Our ref: 8572-ltr-024-LMCC.doc
Date: 20 December 2010

**RE: DA/886/2010 – Retirement Village – Staged Development
Lot 11 DP 830292, Lot 12 DP 830292
40 Burton Road, MOUNT HUTTON NSW 2290, 48 Burton Road, MOUNT
HUTTON NSW 2290**

This letter is in response to your letter to the Applicant dated 22 November 2010 requesting additional information to support the application. This response involves the amendments to some drawings as well as the provision of additional drawings.

RELATIONSHIP WITH ADJOINING LAND

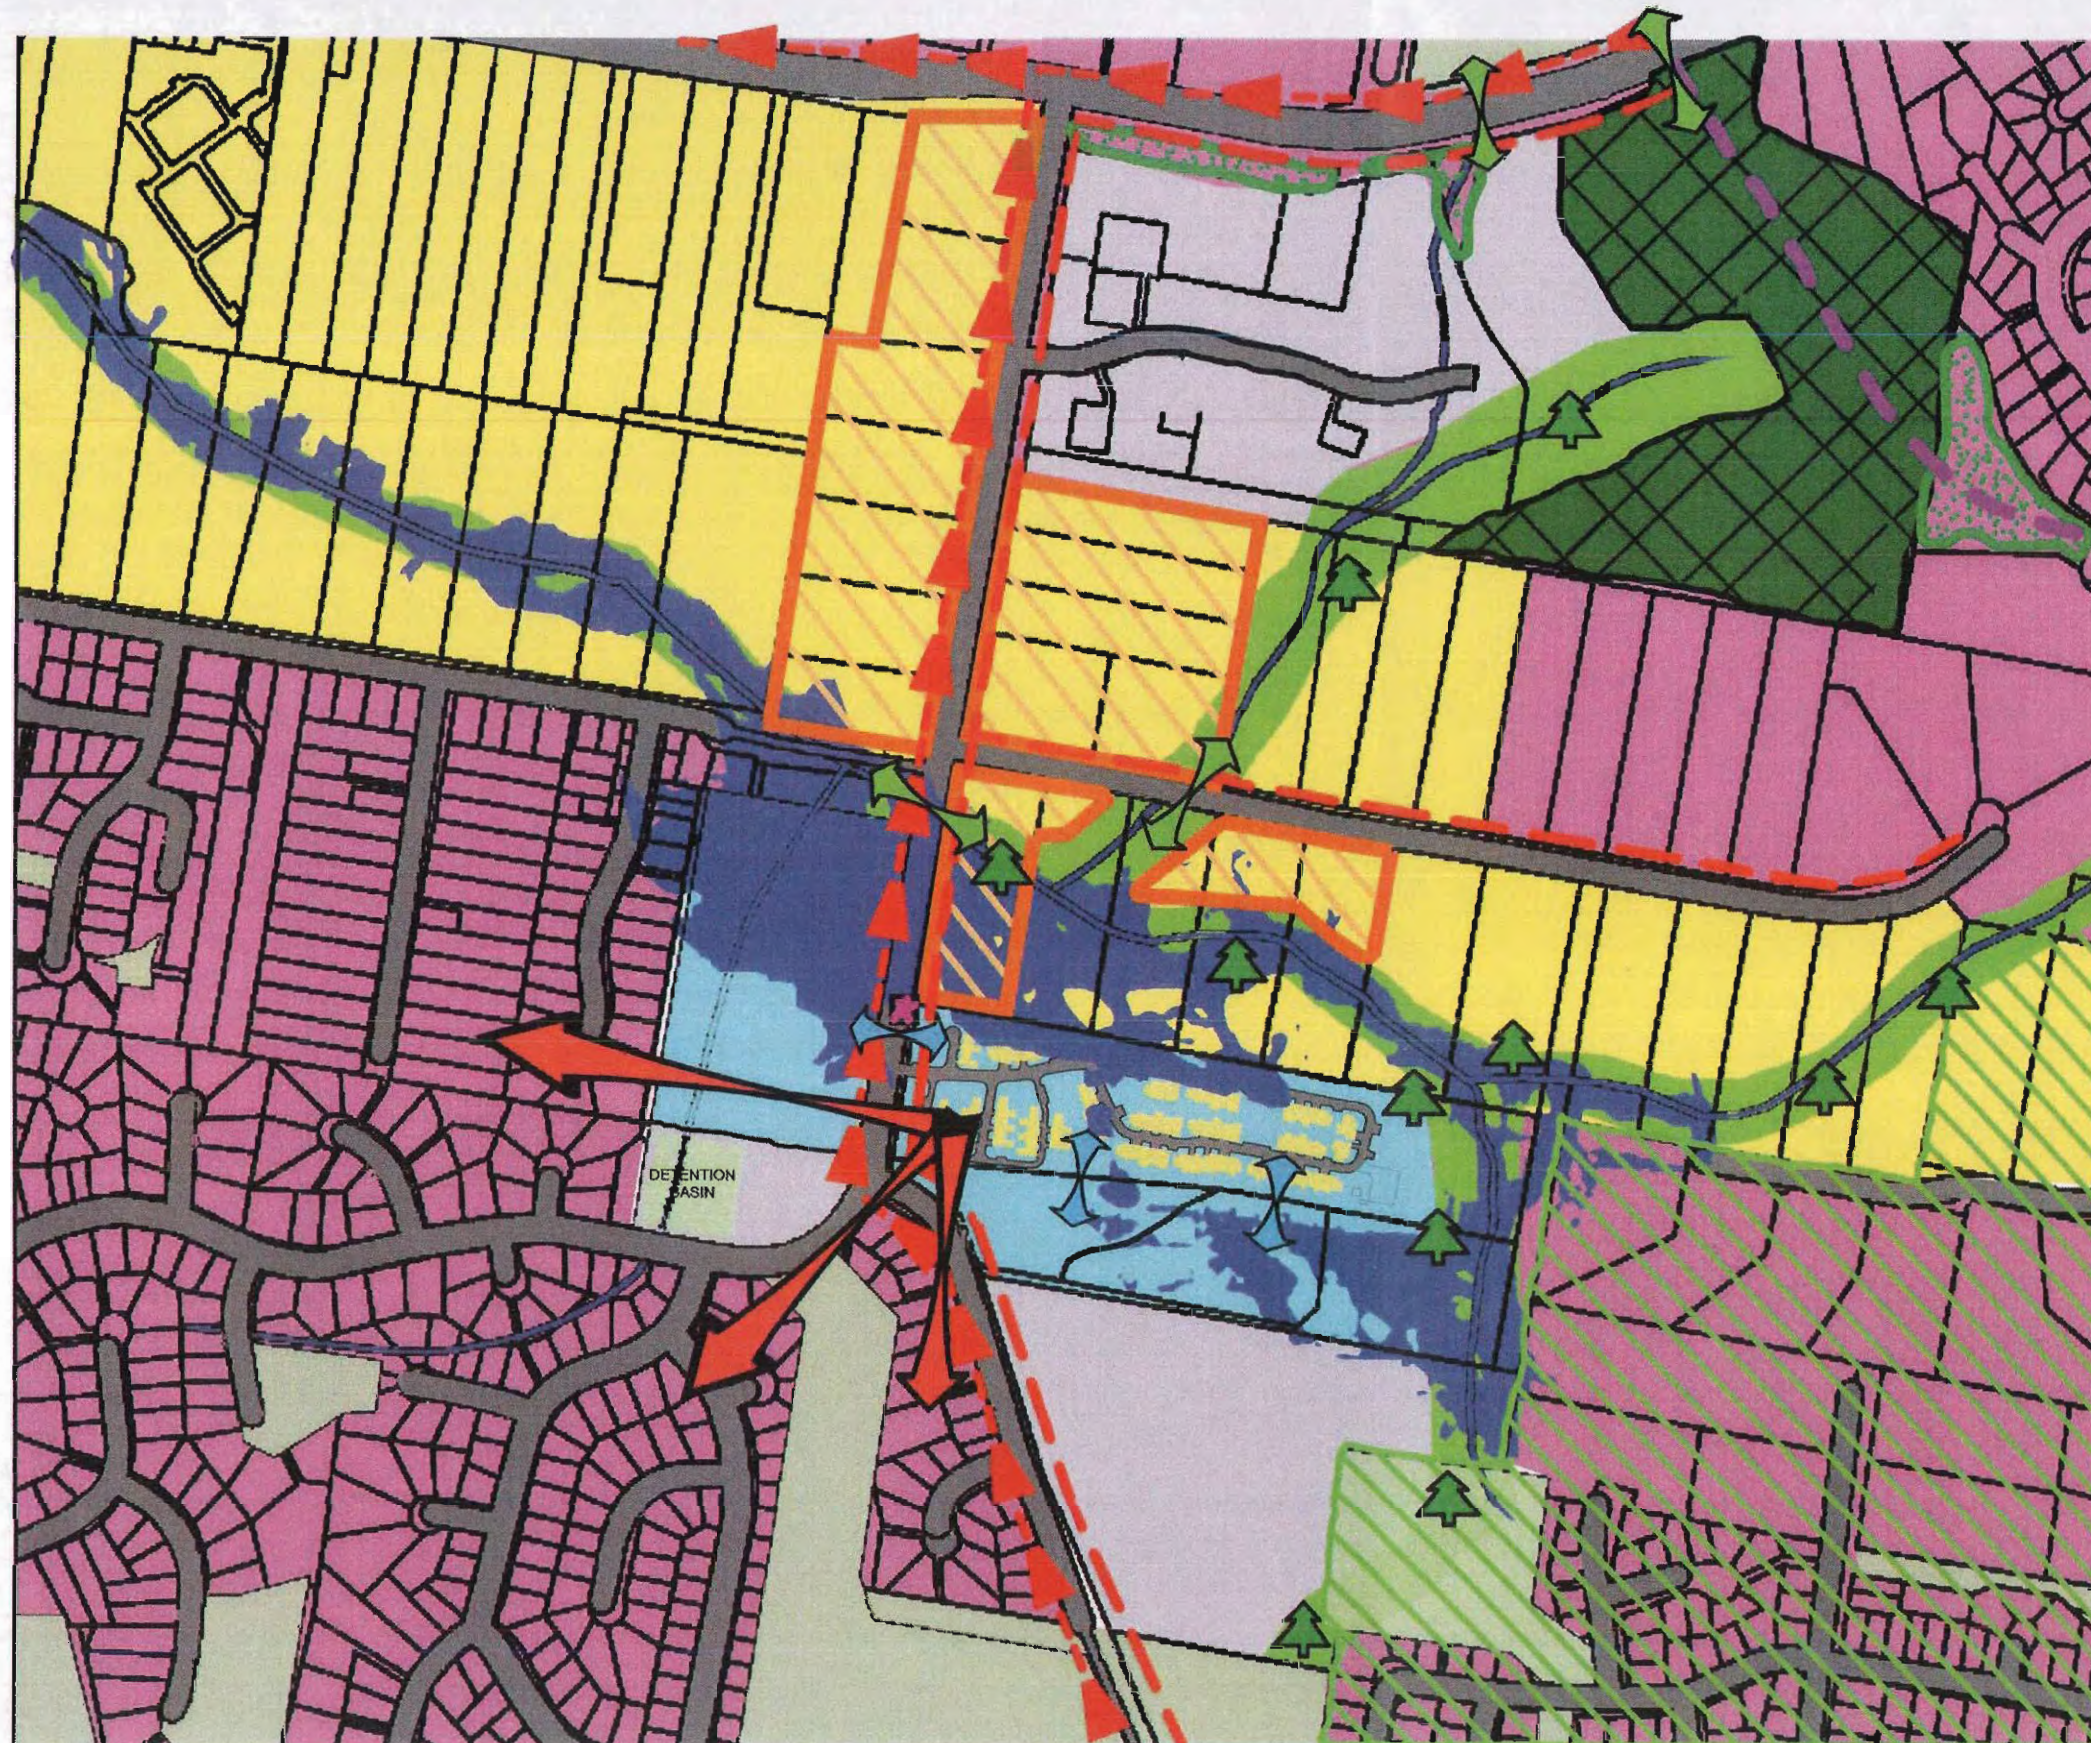
Enclosed as Attachment 1 is a plan of the broader area indicating how the subject site will relate to the surrounding area in consideration of the future capabilities of surrounding sites. Also enclosed in Attachment 1 is a more detailed plan indicating how the subject site relates to adjacent sites also capable of being further developed for purposes other than large lot housing or limited "rural" activities. These plans indicate the surrounding area that has limited future potential as it is flood-prone or is a riparian zone to South Creek. The plan shows that whilst there are zones that promote rural style living predominately to the north of the site there is extensive residential zoning to the south. The properties to the north have further development potential due to being relatively unconstrained and already developed for the purpose of large dwellings on large lots. The subject site falls between these two zonings. The residences proposed for the subject site are compatible with the residential character of the existing residences to the south while the extensive open space within the proposed development is a transition between the residential zone to the south and the rural living zone to the north.

PROPOSED FUTURE RELATIONSHIP PLAN

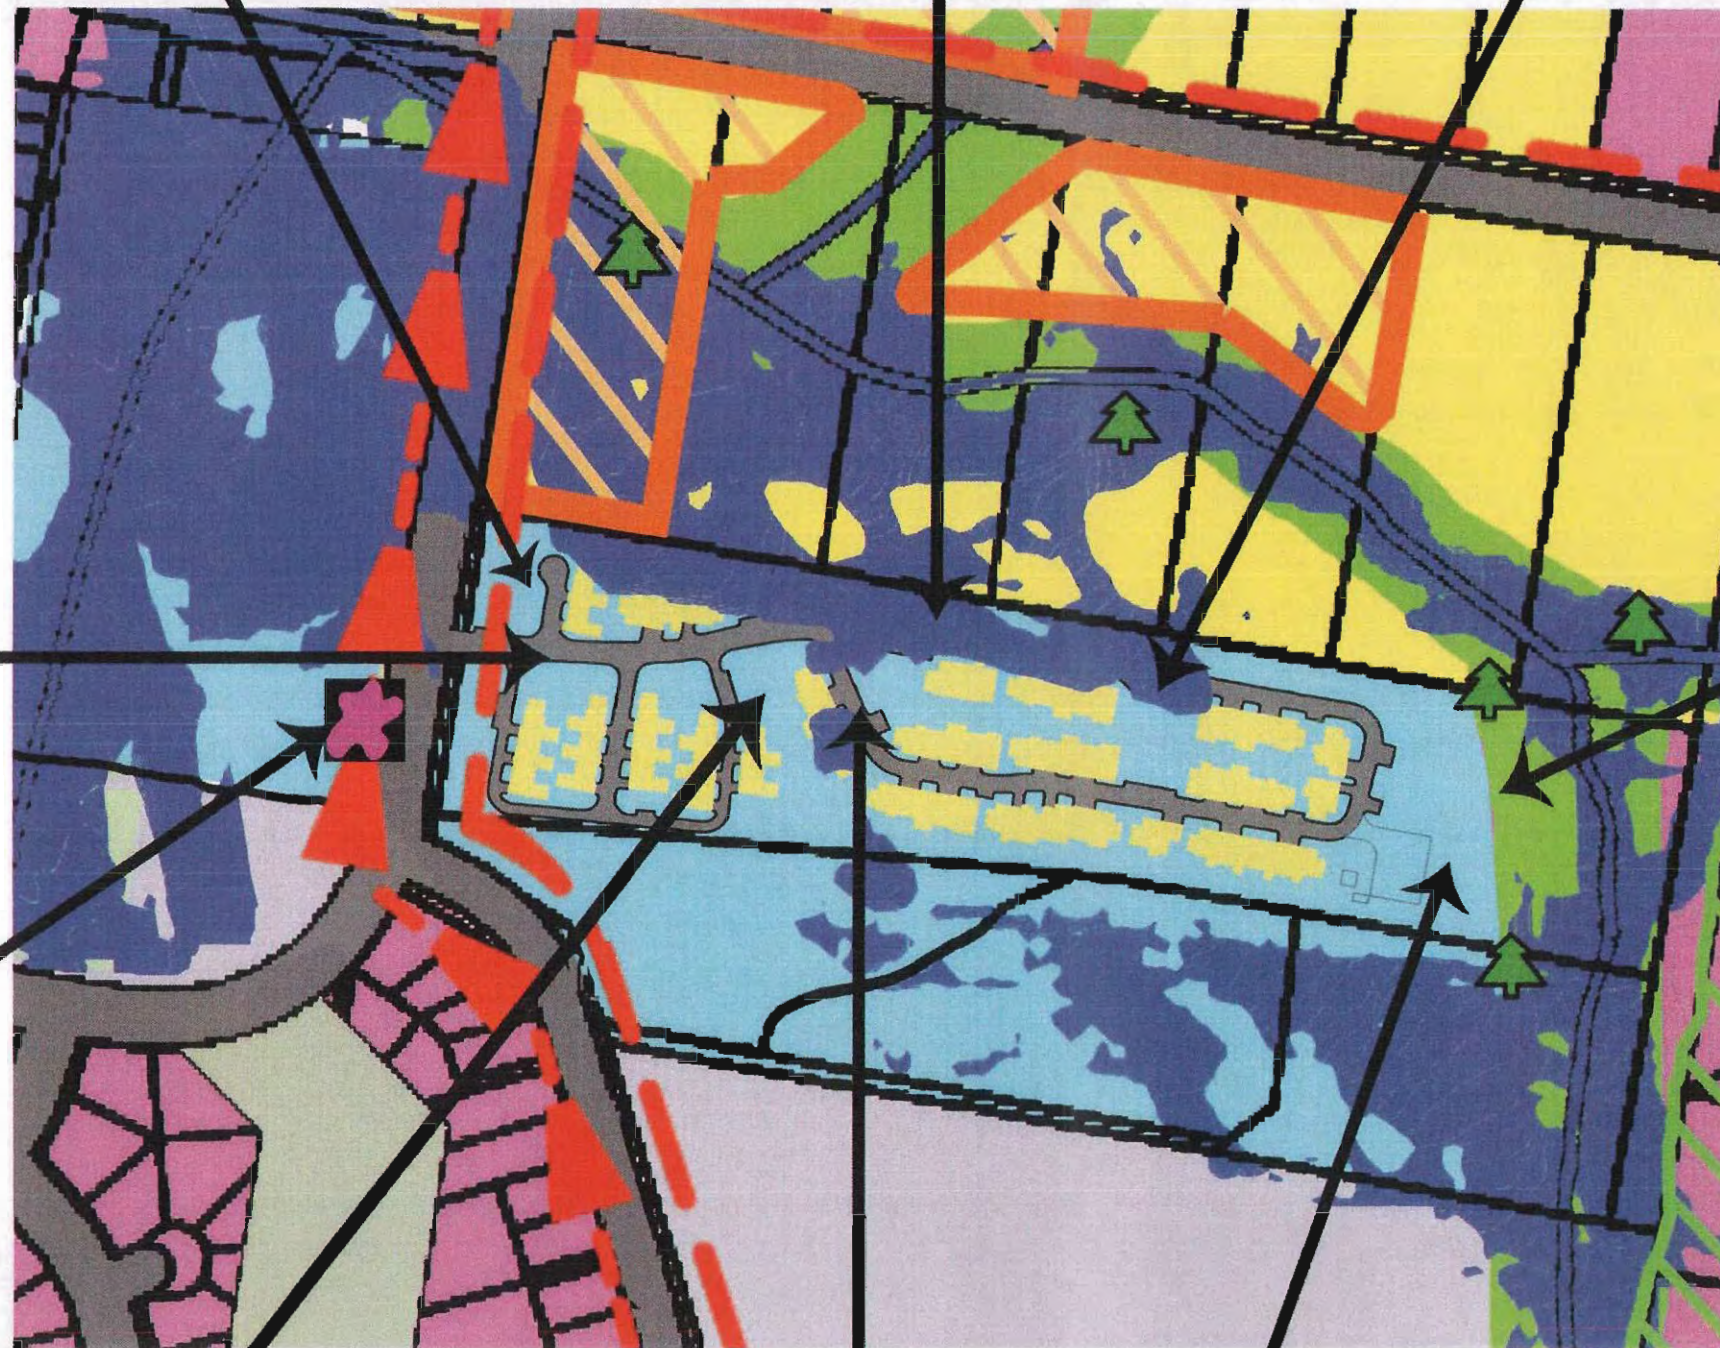
The 'Relationship to Adjoining Land' plan shown in Attachment 1 identifies that the subject site has potential links to the site immediately to the south (Ducks Crossing) and to the site directly opposite across Burton Road. These sites are capable of aged living developments. Road and pedestrian linkages are possible between the sites if this type of development is to occur. The proposed design of the subject site can accommodate both pedestrian and vehicle connectivity between these sites in the future.

DRAWING TITLE
SEDIMENT & EROSION
CONTROL PLAN

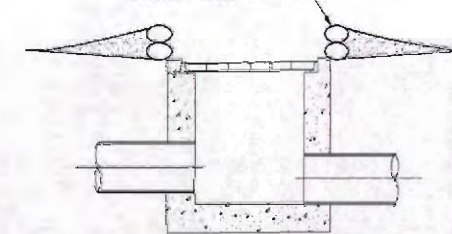
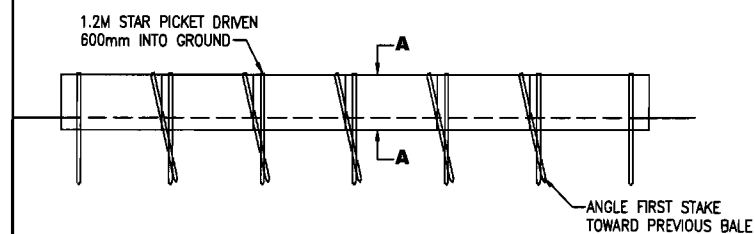
Enclosed as Attachment 4 is a revised Sediment and Erosion Control Plan prepared by Northrop Engineers in accordance with 'The Blue Book' and DCP No.1.
